In re application of	)
	)
Blatter	)
	)
Serial No.:	10/624,315
	) Art Unit
	) 3761
Filed:	July 21, 2003
	)
For:	APPARATUS AND METHODS FOR
	FACILITATING REPEATED VASCULAR ACCESS
	)
	)
Examiner:	Leslie R. Deak
	)
	)
Patent No.:	7,118,546 B2
	)
	)
Issue Date:	October 10, 2006
	)

REQUEST FOR A CERTIFICATE OF CORRECTION  
UNDER 37 C.F.R. § 1.323

CERTIFICATE OF CORRECTION

PATENT NO. : 7,118,546 B2  
DATED : October 10, 2006  
INVENTOR(S): Blatter

Fig. 11B

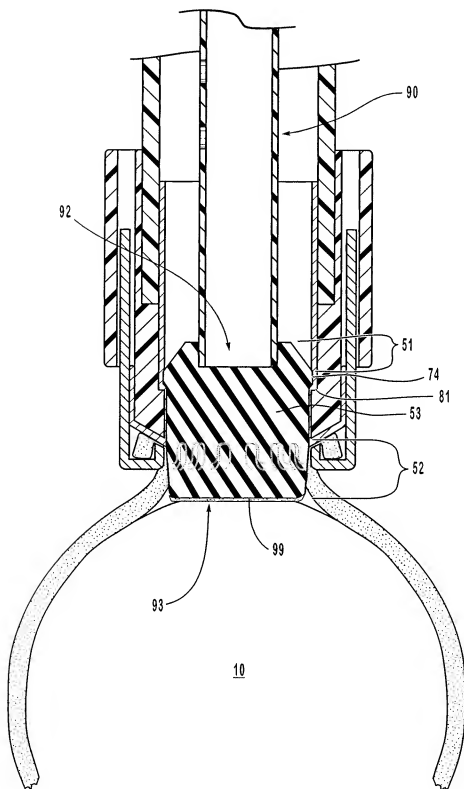
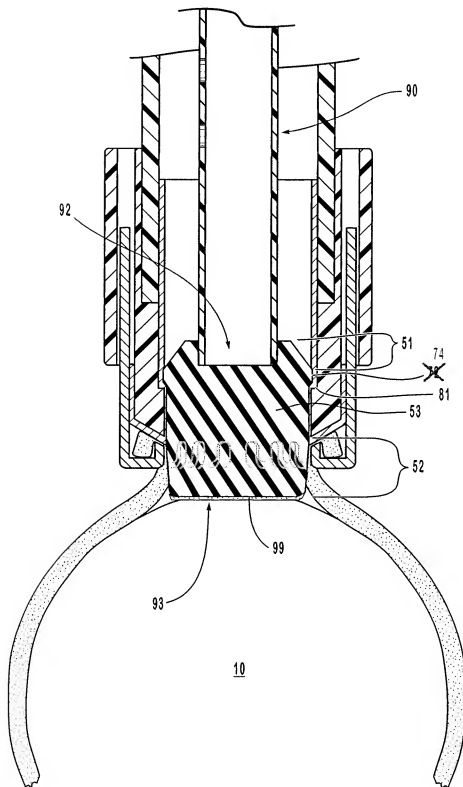
In accordance with the provisions of 37 C.F.R. § 1.323 which implement 35 U.S.C. § 255, the Commissioner is respectfully requested to issue a Certificate of Correction to correct mistakes in the above-identified patent. The enclosed Patent Office Form 1050 reflects the desired corrections. Note that attached are replacement sheets for drawing sheets 17 and 27,

including annotated copies of the original drawing sheets. The changes are to correct numbering mistakes.
